**SUBJECT: NEW VEHICLE DEMONSTRATION / DELIVERY HOLD -
 Safety Recall 22S09 – Supplement #2**

Certain 2017 - 2022 Model Year F-250/F-350 Vehicles Equipped with a 6.2L/7.3L Gas Engine, Crew Cab/Super Cab, 160"/164" Wheelbase, 4x4, and One-Piece Aluminum Driveshaft
 Loose/Sagging Underbody Insulator

New! REASON FOR THIS SUPPLEMENT

FIGURE 3

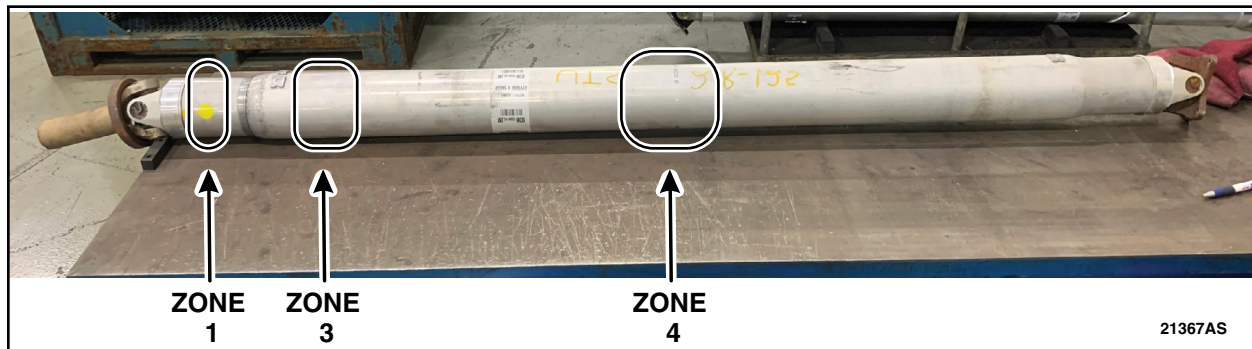
2. Inspect Zones 1, 3 and 4 of the rear driveshaft for any marks caused by the front and/or rear edges of the passenger side insulator. Are there any marks present in Zones 1, 3 or 4? See Figure 3.

Yes – Proceed to step 3.
No – Proceed to step 5.

FIGURE 4

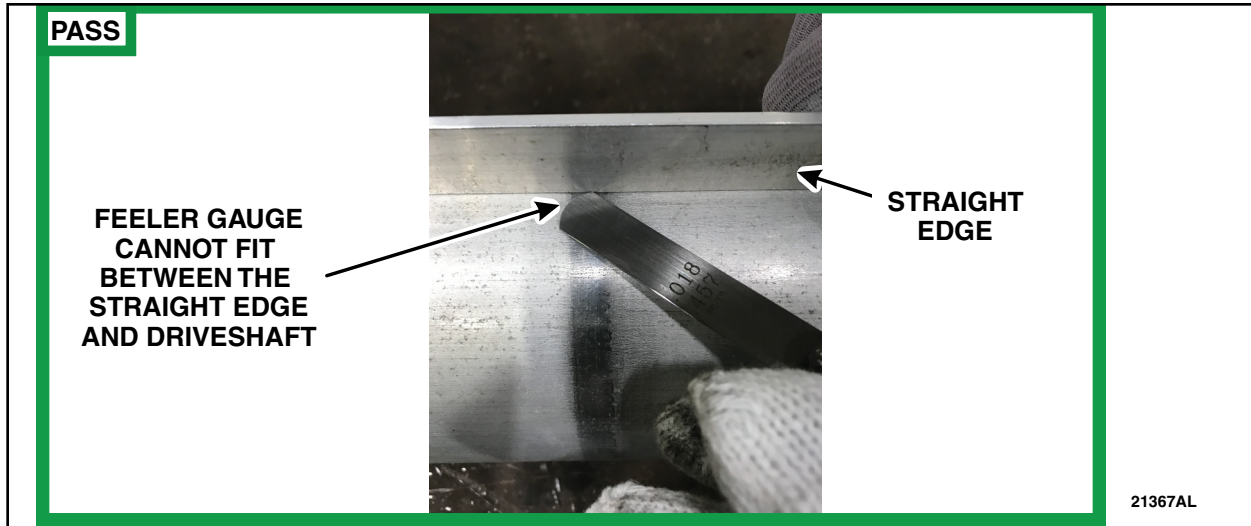
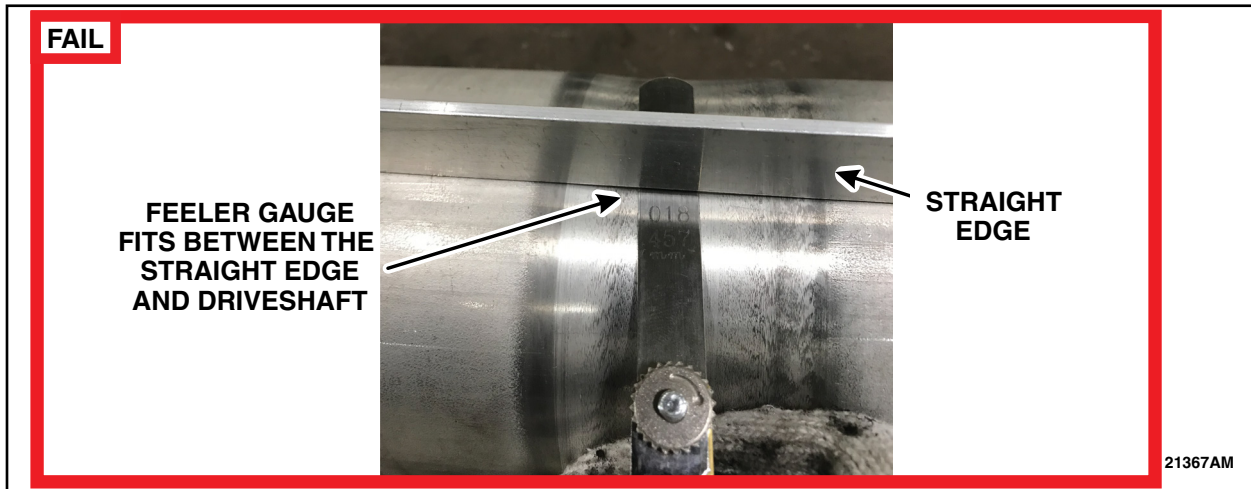
4. Place a straight edge along the driveshaft over the wear mark and attempt to fit a 0.018in (0.45mm) feeler gauge between the flat edge and the wear mark. Can the feeler gauge fit between the straight edge and anywhere along the wear mark? See Figures 4 and 5.

Yes – Does not pass inspection. Contact the SSSC and provide a picture of the driveshaft with the feeler gauge fitting between the straight edge and wear mark. Once approved, rear driveshaft replacement will be required, but do not install at this time. Proceed to step 7.
No – Passes inspection. Proceed to step 5.

FIGURE 7

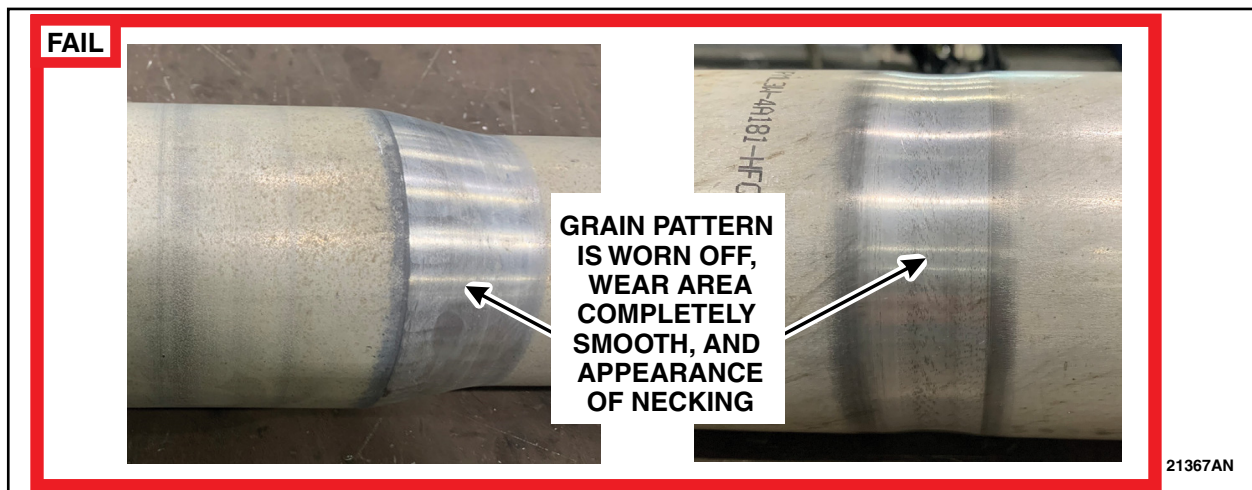
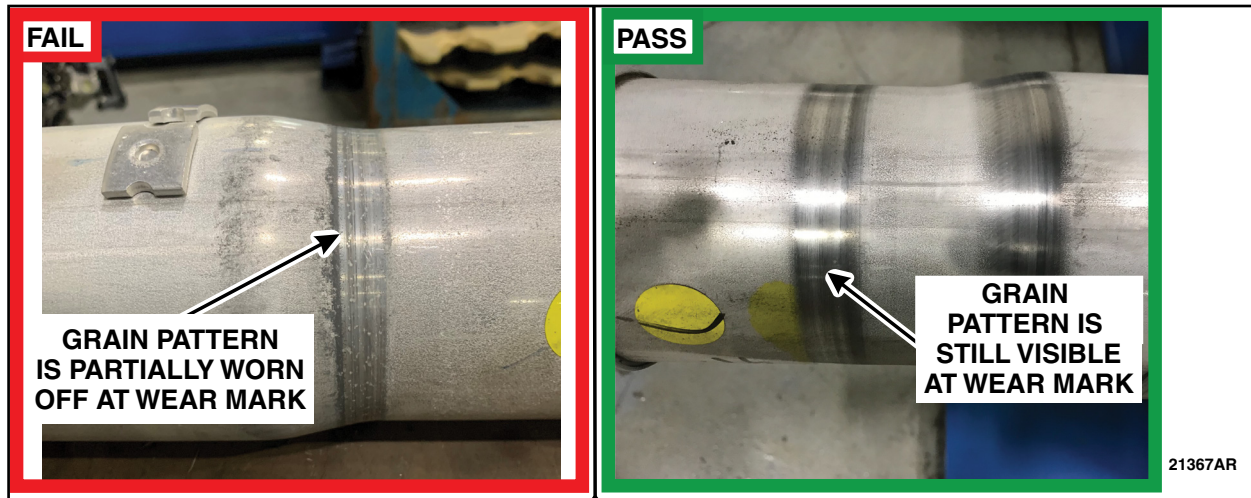
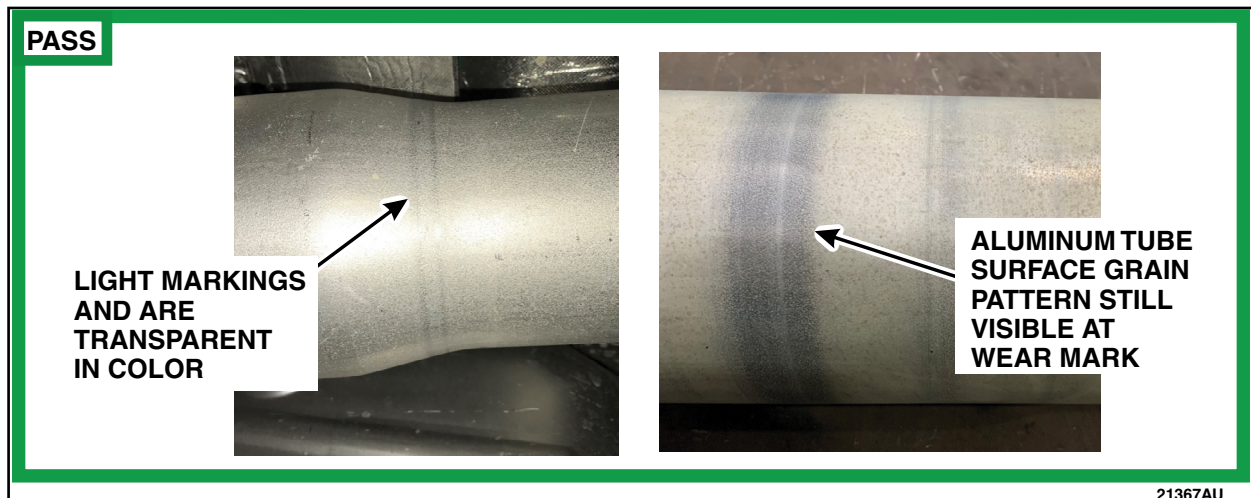
6. Inspect the marks found on Zone 2. Is the aluminum tube surface grain pattern worn off, completely smooth, or have an appearance of necking? See Figures 7 through 10.

Yes – Does not pass inspection. Contact the SSSC and provide a picture of the driveshaft with the grain pattern worn off. Be sure to show a clear image of the grain pattern missing. Once approved, rear driveshaft replacement will be required, but do not install at this time. Proceed to step 7.

No – Passes inspection. Driveshaft may be reused. Proceed to step 7.
